HISTORIC AND DESIGN REVIEW COMMISSION

February 21, 2018

HDRC CASE NO: 2018-022
COMMON NAME: 825 N ST MARYS
LEGAL DESCRIPTION: NCB 801 BLK 27 LOT E 48.33 FT OF 17
ZONING: D, RIO-3
CITY COUNCIL DIST.: 1
APPLICANT: Mitch McManus
OWNER: 825 N St Mary's, LLC
TYPE OF WORK: Construction of five, three story residential structures
APPLICATION RECEIVED: December 20, 2017
60-DAY REVIEW:
REQUEST:

The applicant is requesting a Certificate of Appropriateness to construct five, three story residential structures on the vacant located at 825 N St Mary's street.

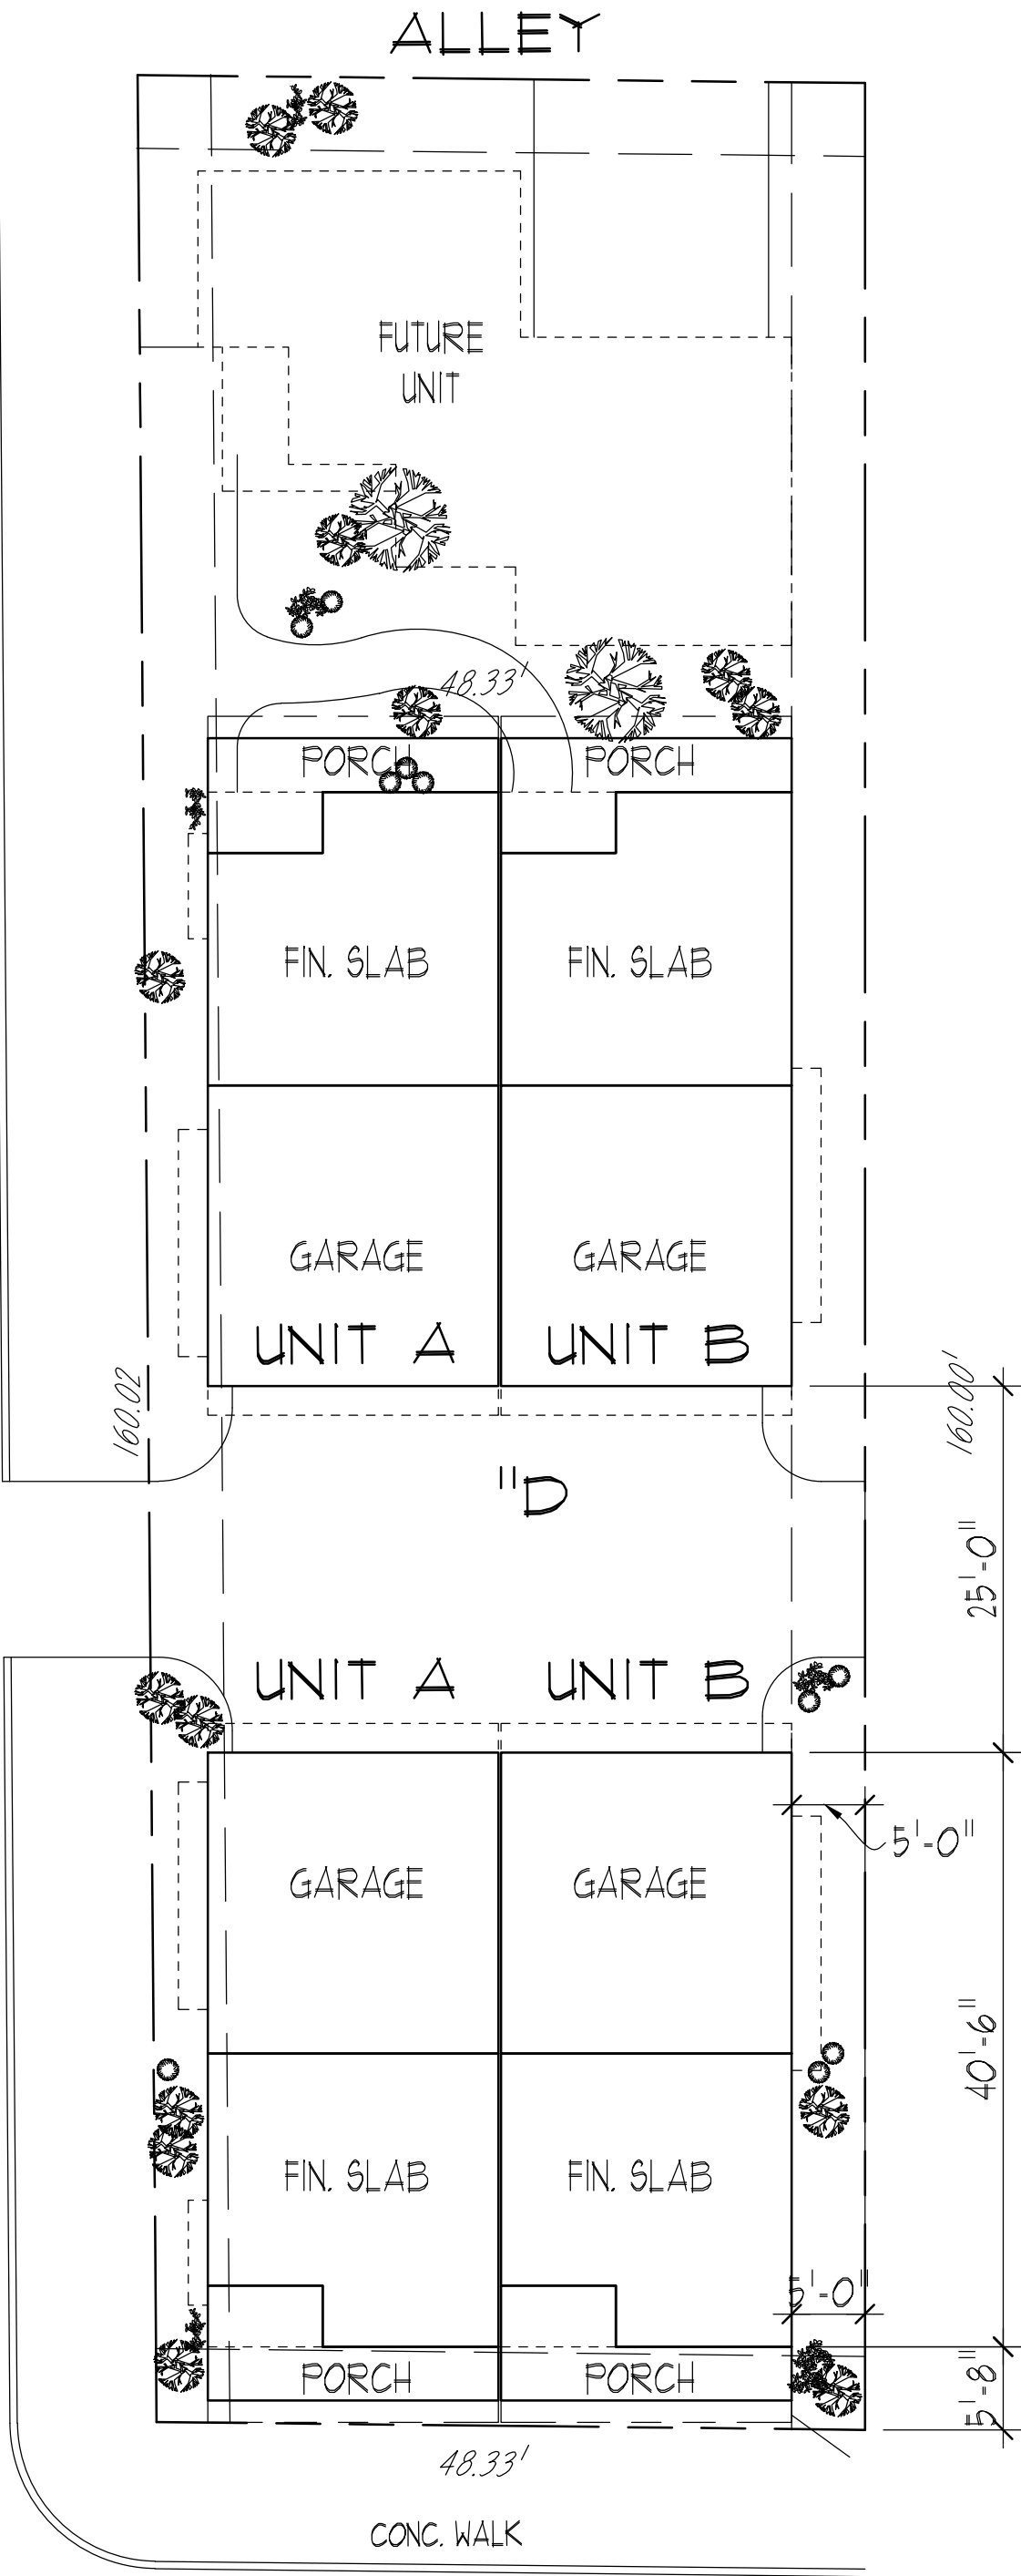
- a. The applicant has proposed to construct five, three story residential structures on the vacant lot at 825 N St Mary's at the corner of N St Mary's and Richmond Avenue. Four of the proposed units feature matching floor plans and elevations. The fifth unit is noted as a future unit of construction, per the site plan.

- c. **ORIENTATION** – The applicant has proposed to orient the proposed new construction in a manner that street frontage will be provided the two units fronting N St Mary's, the primary street. Per the UDC Section 35-673(b), buildings should be clustered as to provide courtyards or active spaces. The proposed new construction is consistent with the UDC.

FRONT ELEVATION

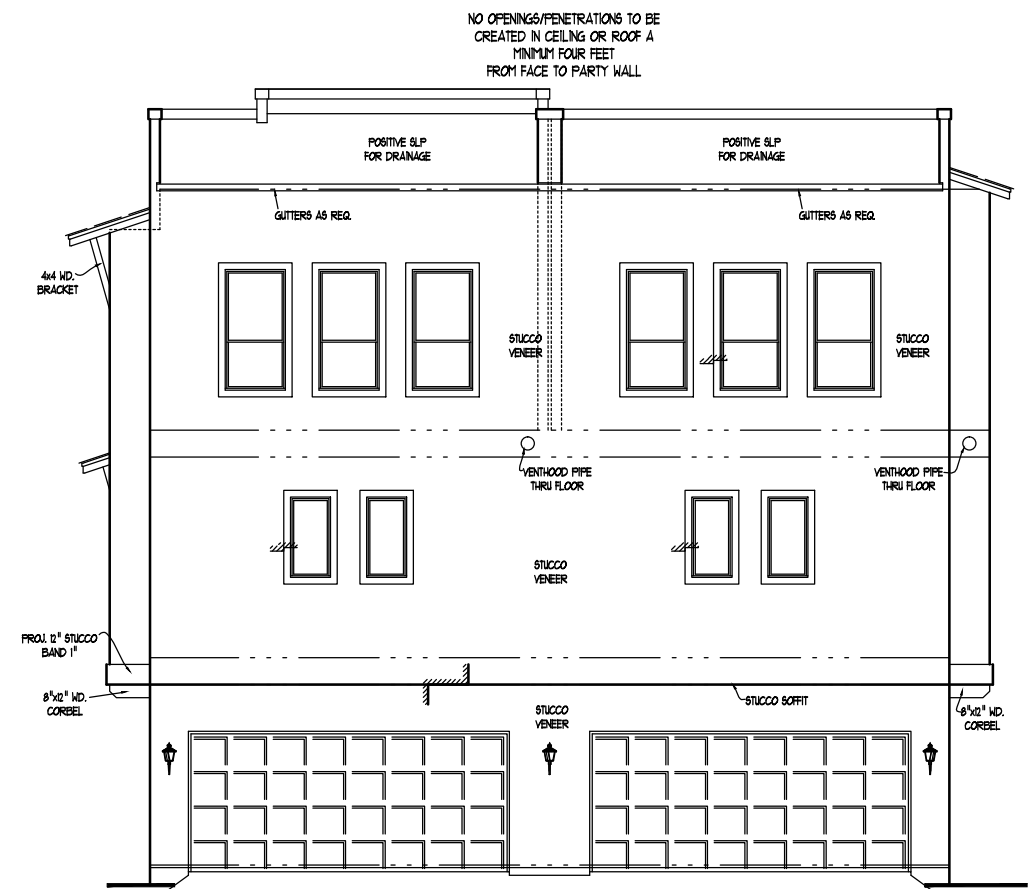
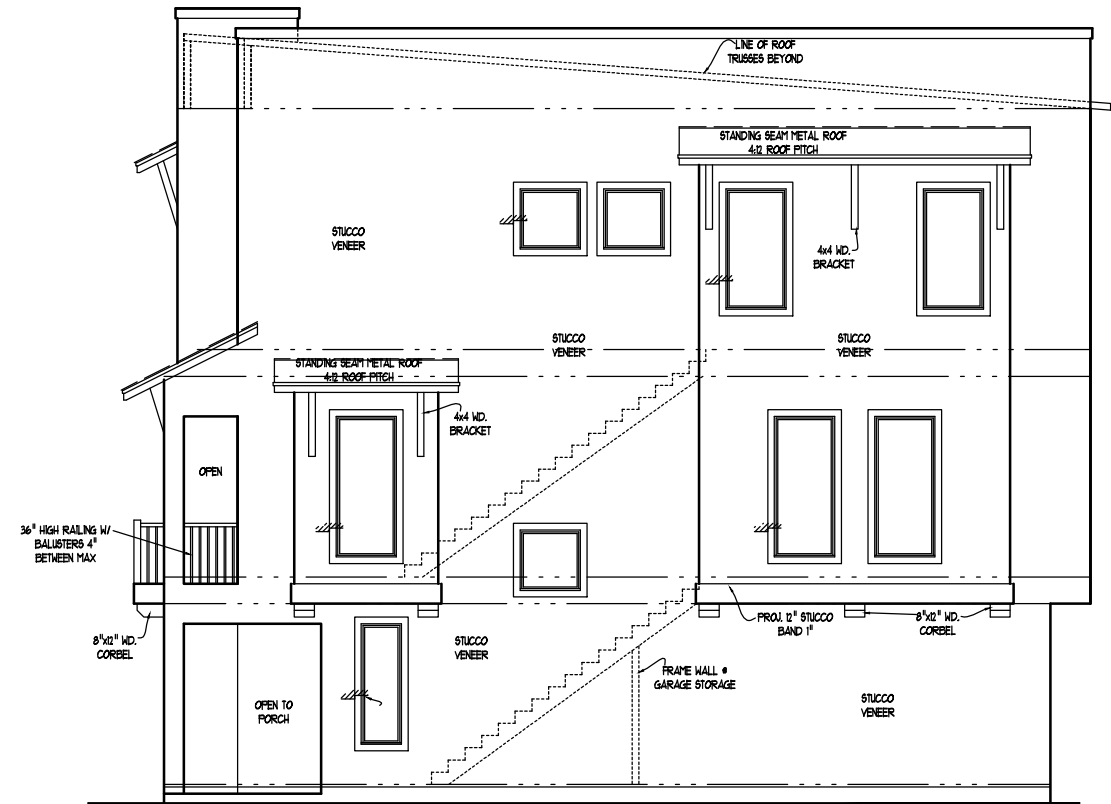
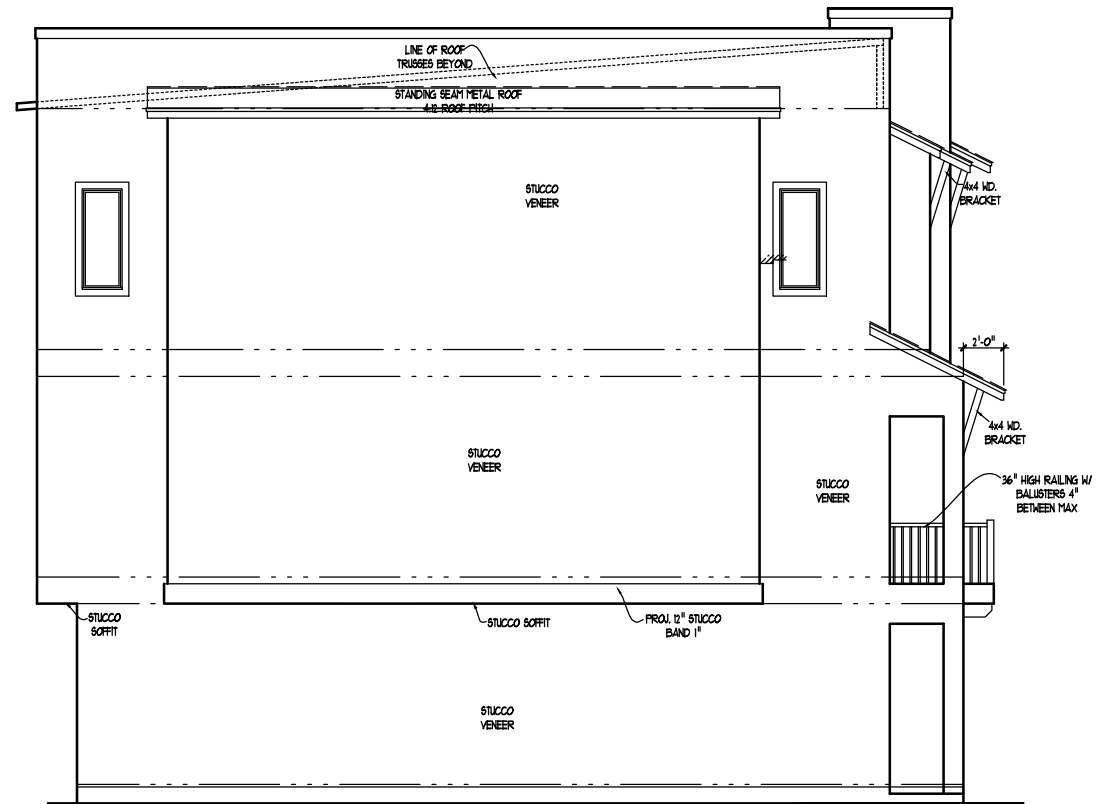
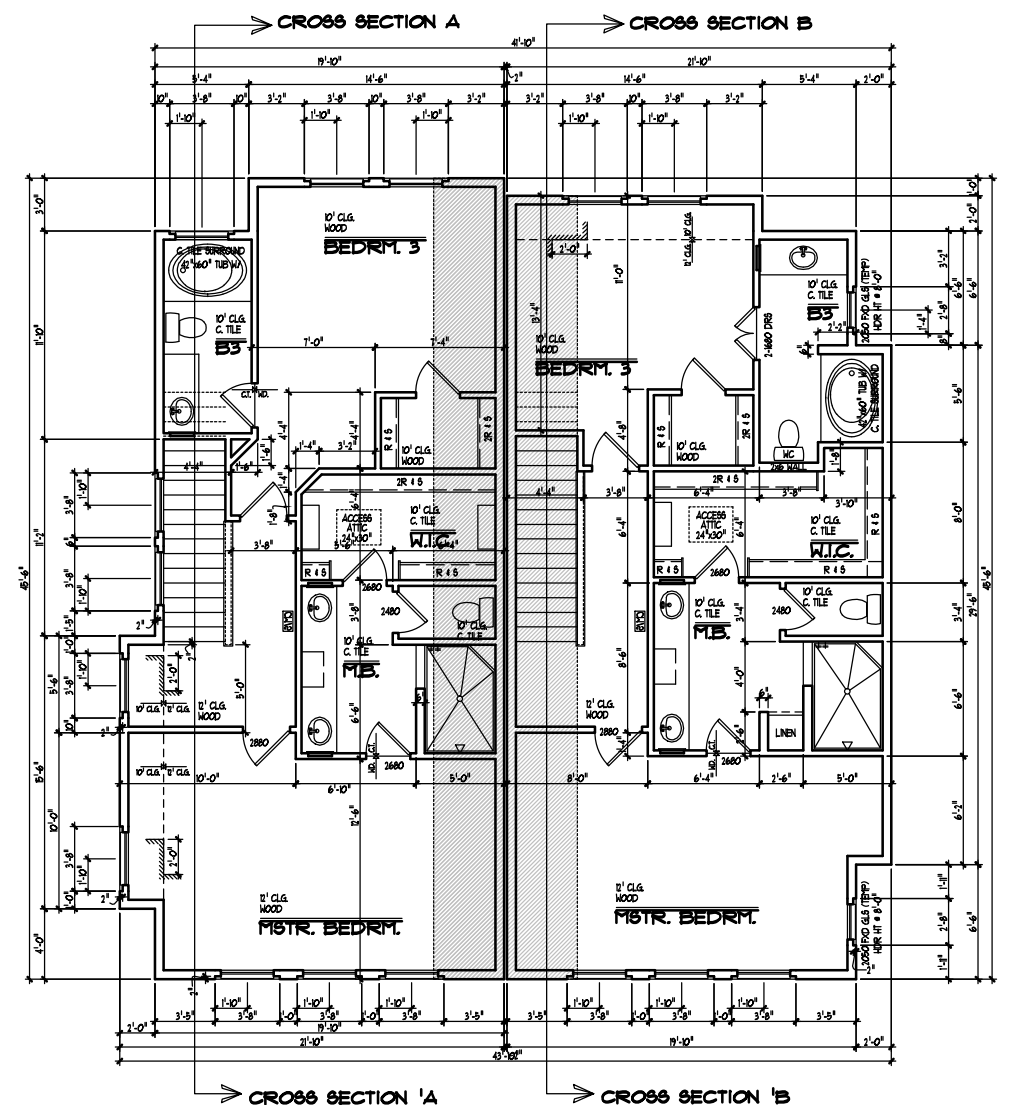
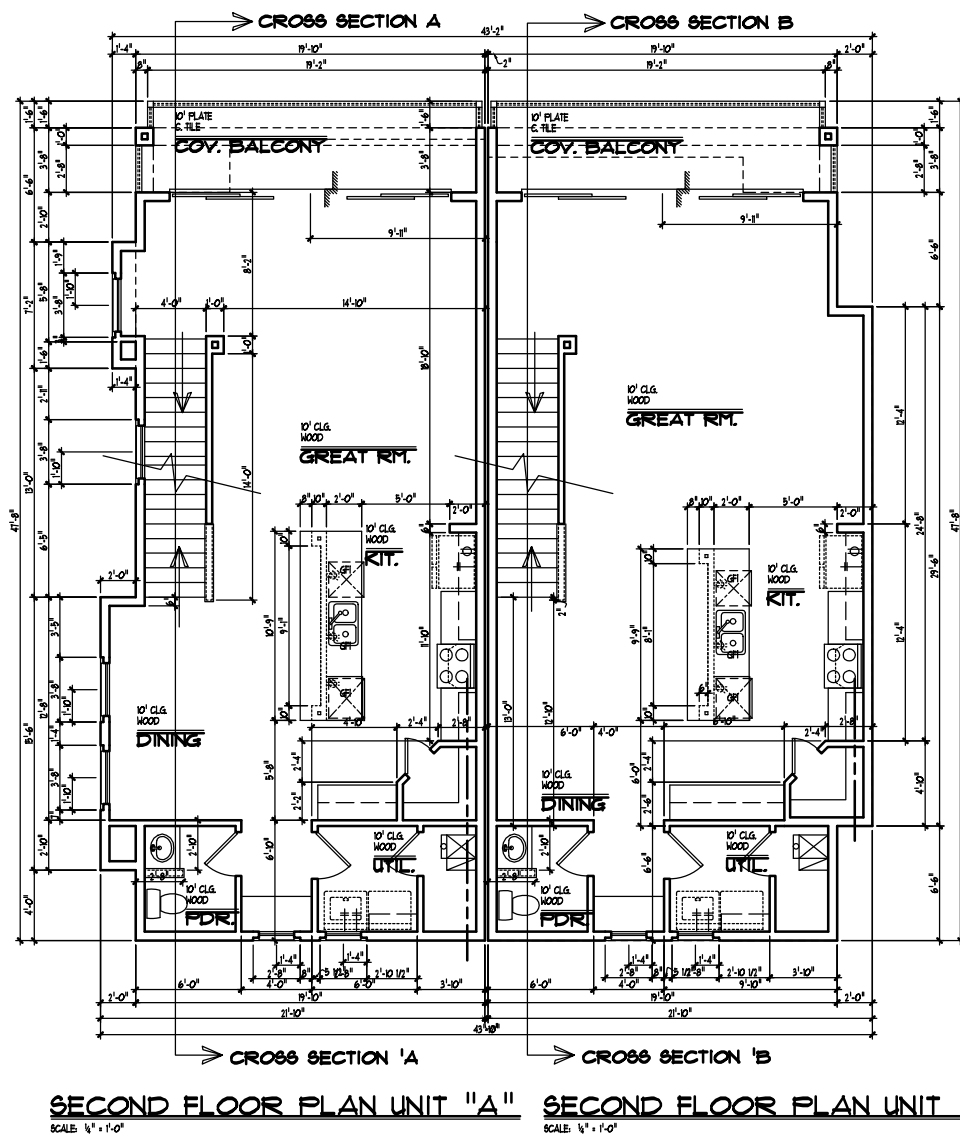
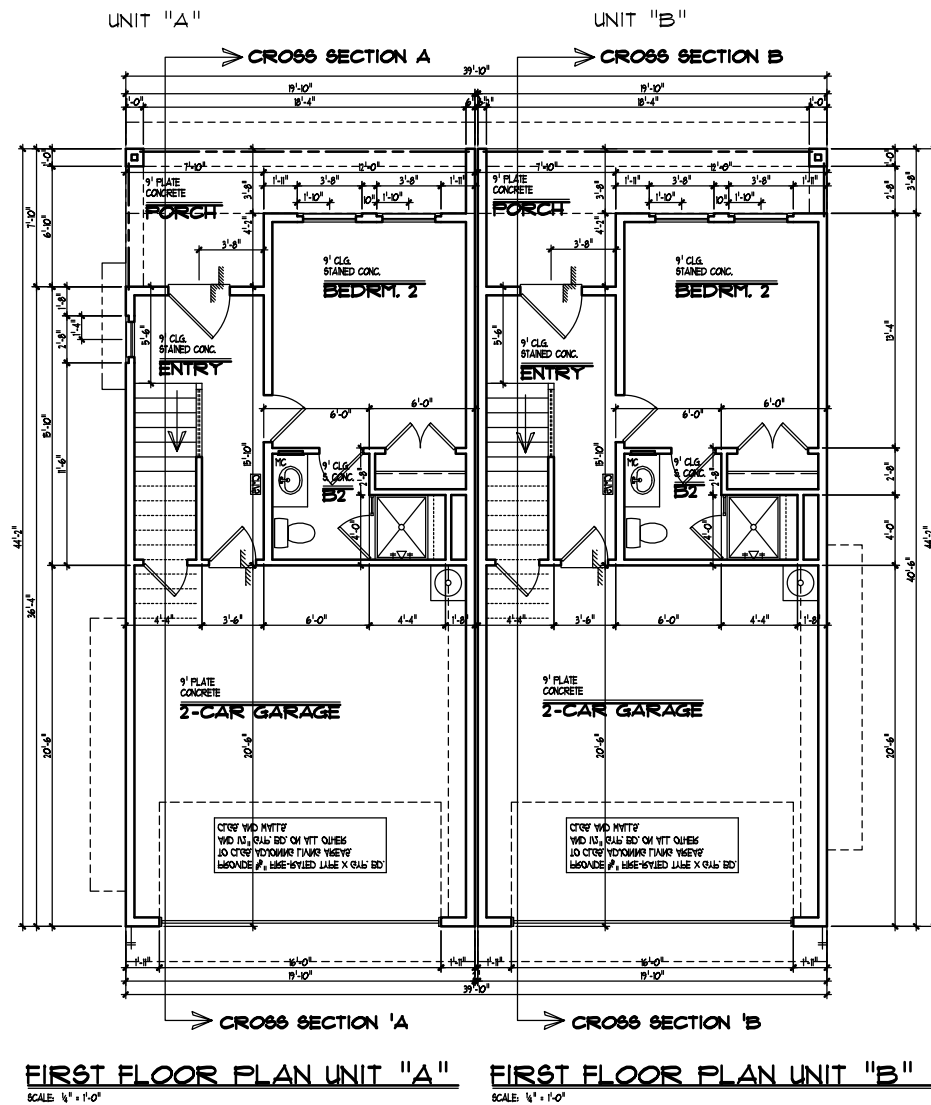
- e. **WINDOW & DOOR OPENINGS** – The UDC Section 35-674 (2) states that windows help provide a human scale to a façade and therefore should be recessed at least two (2) inches within solid walls, they should relate in design and scale to the spaces behind them, they shall be used in hierarchy to articulate important places on the façade and grouped to establish rhythms and that curtain wall systems should be designed with modulating features such as projecting horizontal and/or vertical mullions. Generally, the applicant has proposed window and door openings that feature proportions that are found both in historic and contemporary architecture in the vicinity of the proposed new construction. Staff finds the proposed opening to be appropriate and consistent with the UDC.

- f. **FAÇADE ARRANGEMENT** – For proposed new construction in the River Improvement Overlay, each façade must be organized into three distinct segments; a base, midsection and cap. The base consists of front porches with recessed entrances, the mid-section features floor to ceiling glass with protruding balconies and the cap features projecting and recessed wall planes and a parapet wall. The proposed façade arrangement and separation is consistent with the UDC Section 35-674(e).
